# OHIO BUILDING CODE PLAN REVIEW RECORD

## CITY OF CENTERVILLE

Centerville Washington Township Park District  
221 N. Main Street

Outlined below, please find a response to your review letter of December 14, 2005. For your convenience, our responses are numbered in the same manner as your original letter and responses are typed in bold. As discussed in our conversation of December 21 your items 1, 7, 8 and 9 deal specifically with information to be contained in the construction documents. The remaining items are included and shall be installed in accordance with the referenced section as clarified in the previous response letter.

**A-302**

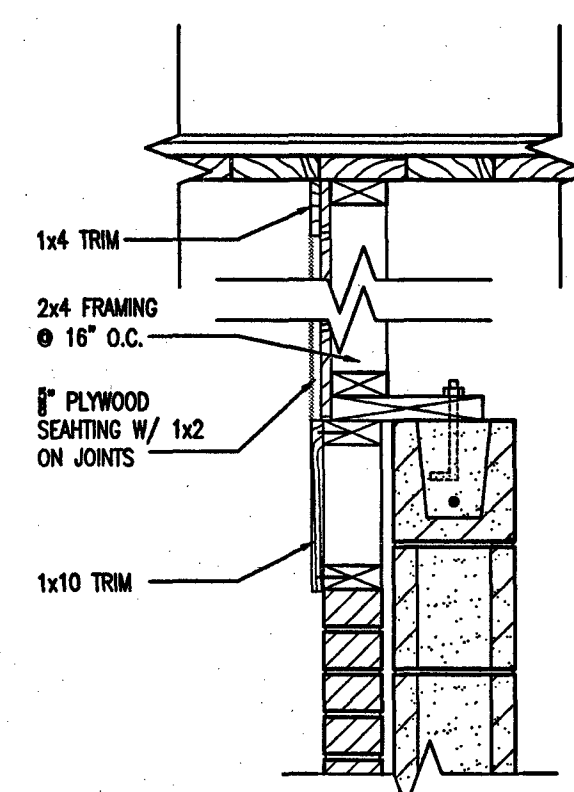
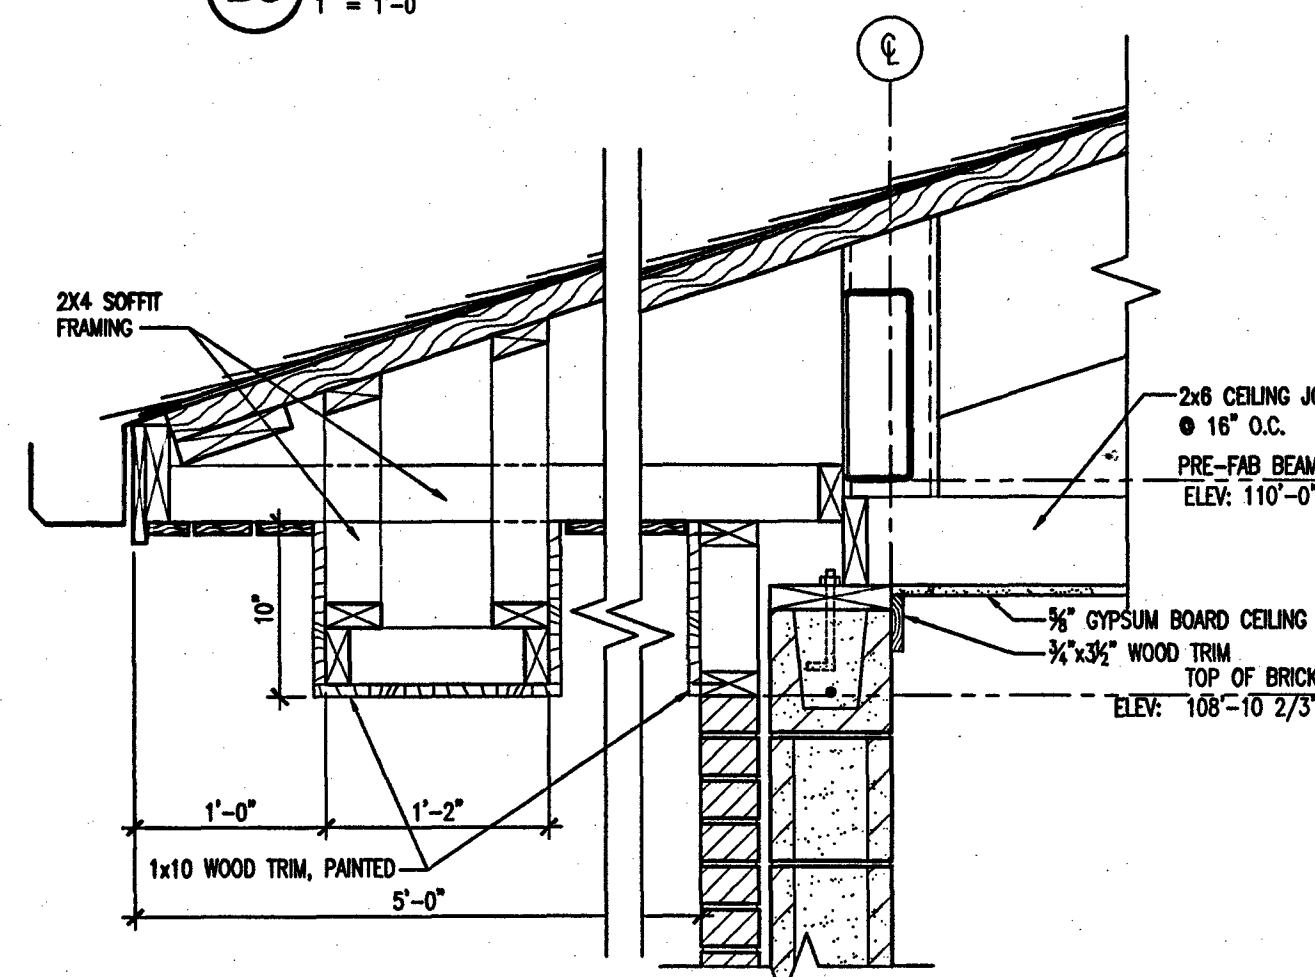
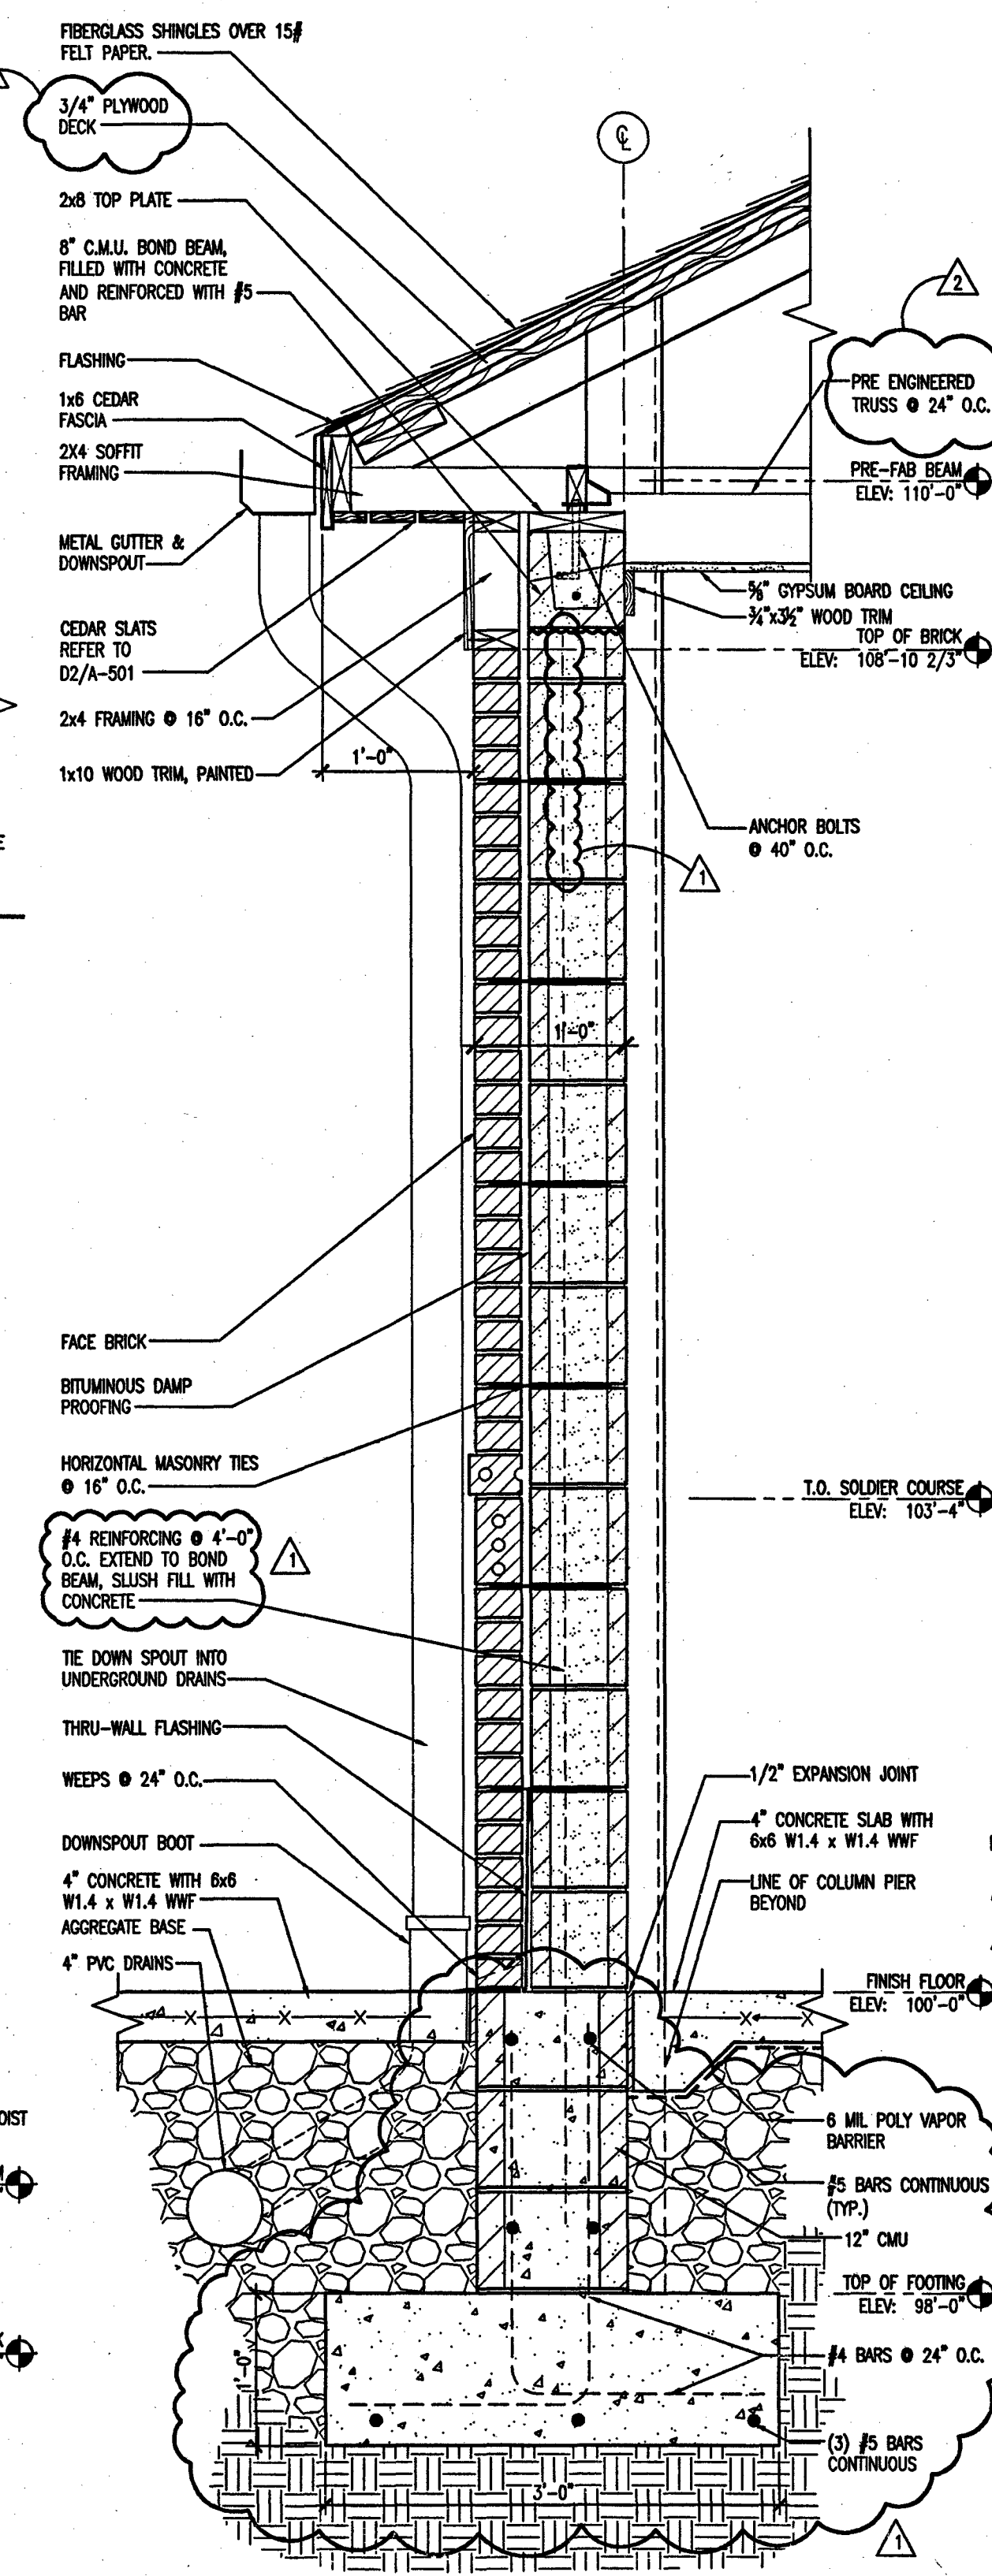
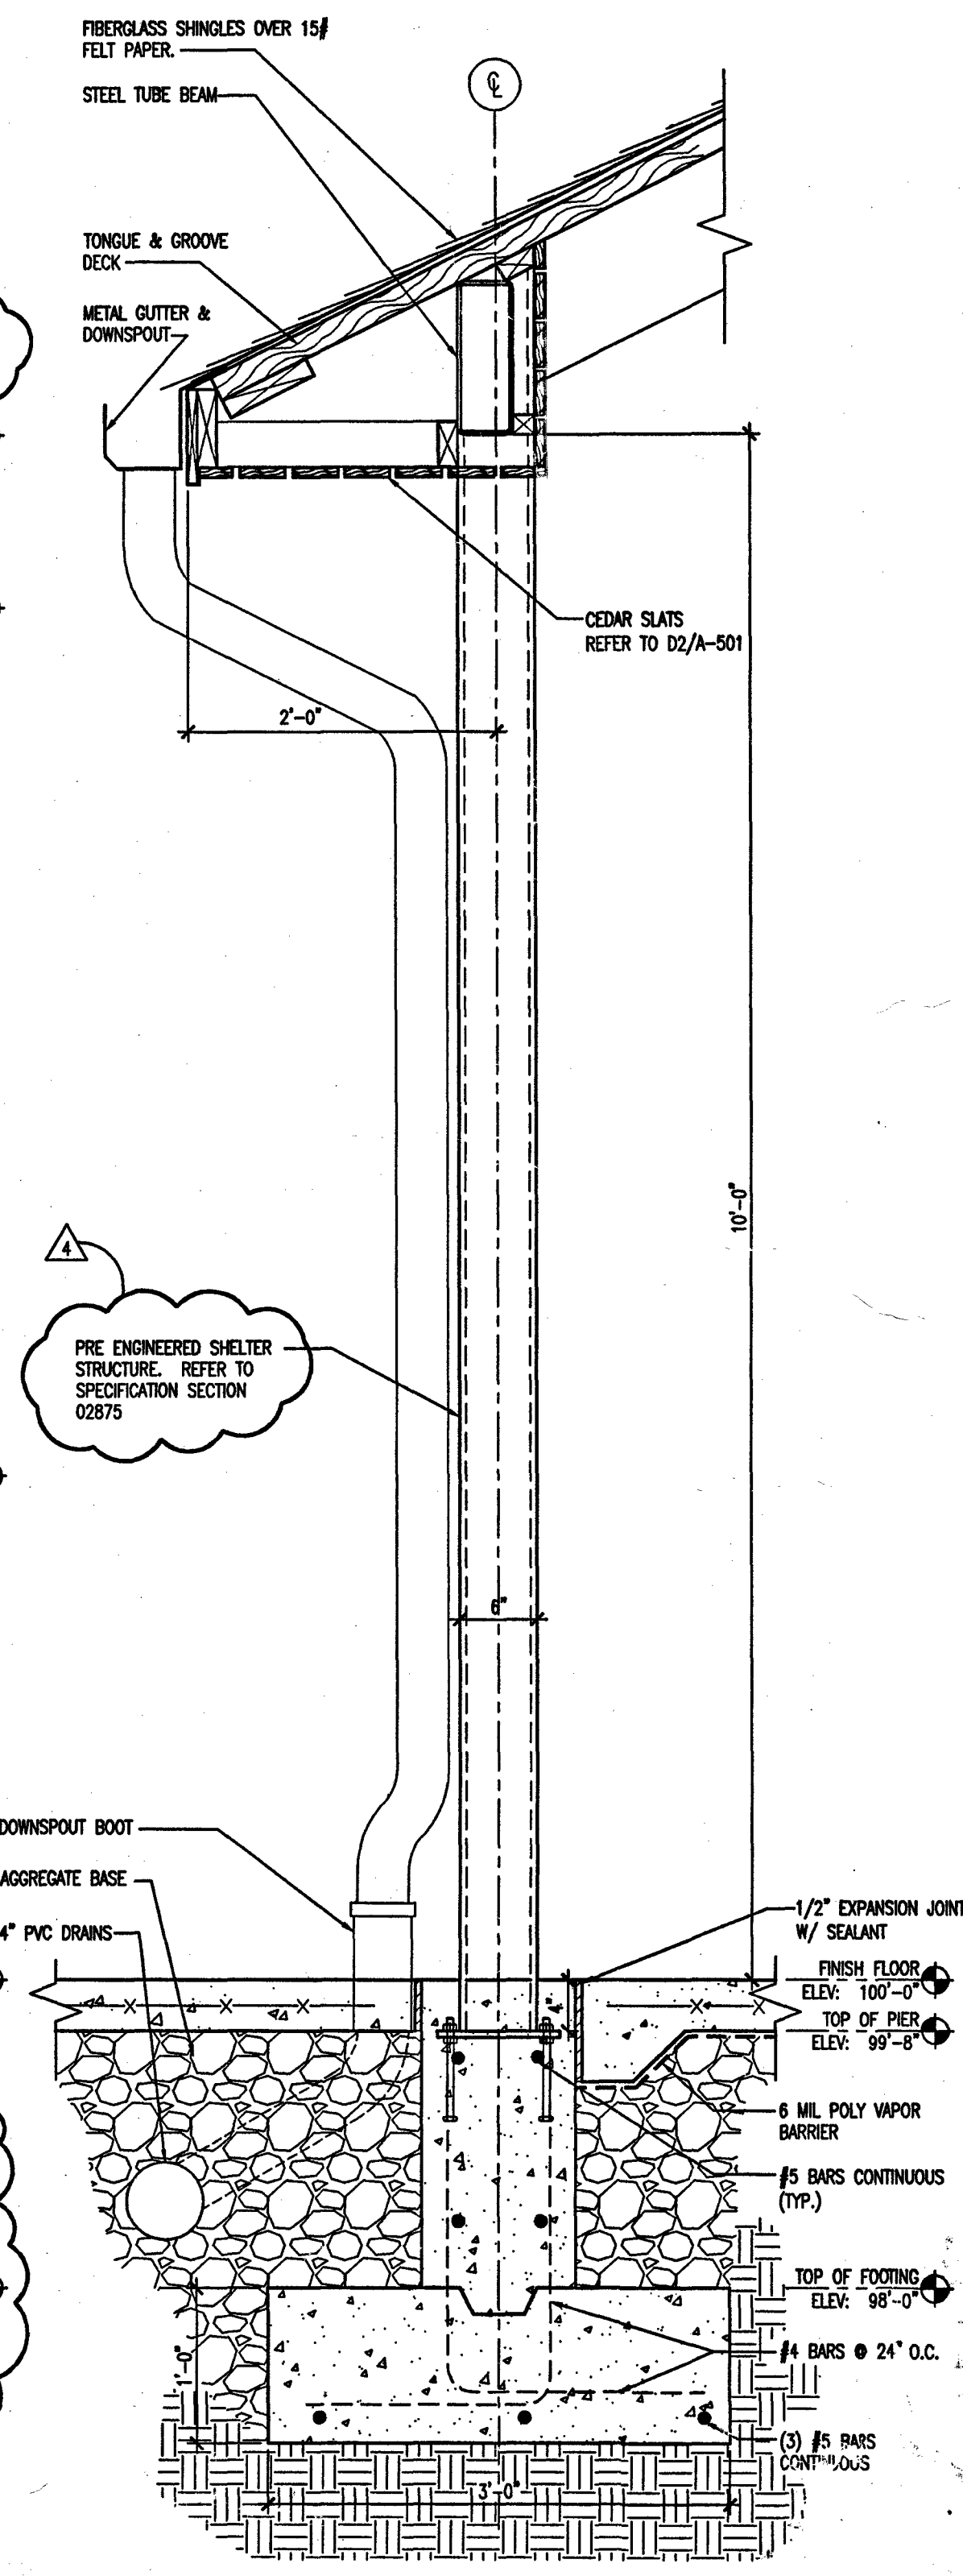
16. The construction documents shall show the size, section and relative locations of all structural members, with floor levels, column centers and offsets fully dimensioned. – Section 1603.1. No structural framing information is provided for the Activities Center.

***Structural design information has been added to sheet A-302.***

**D5** Central Exhaust System Detail  
N.T.S.

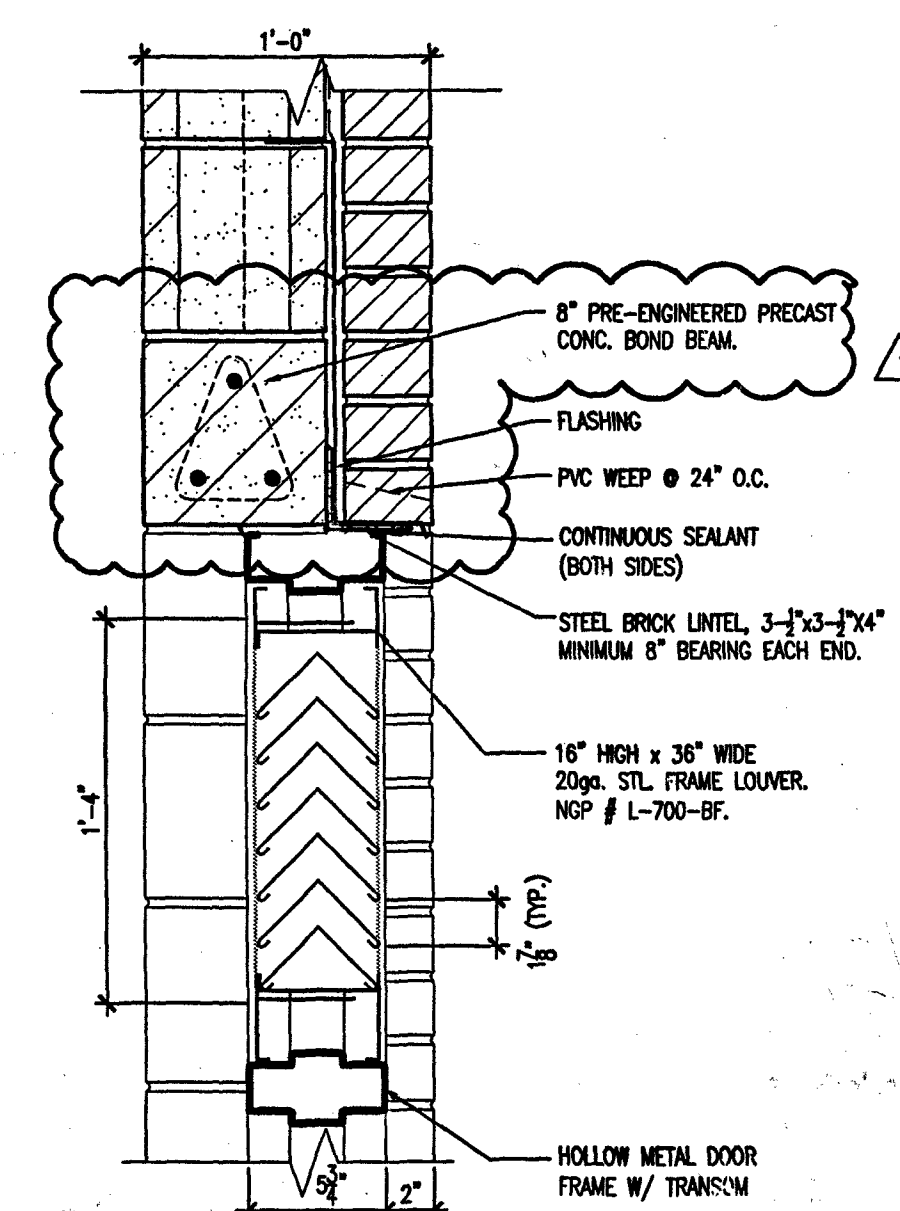
Item 9. All mechanical equipment, appliances and systems shall be constructed, installed and maintained in accordance with the Ohio Mechanical Code Section 2801.1. Where appliances are located on a roof having a slope of 3:12 or greater shall be provided with a platform in accordance with Section 306.6. Provide details for required platforms.

***Please reference drawing A-501 detail D5 shows CFM exhaust from each space in compliance with table 403.3. Outside air is drawn in through door louvers to properly ventilate the space.***
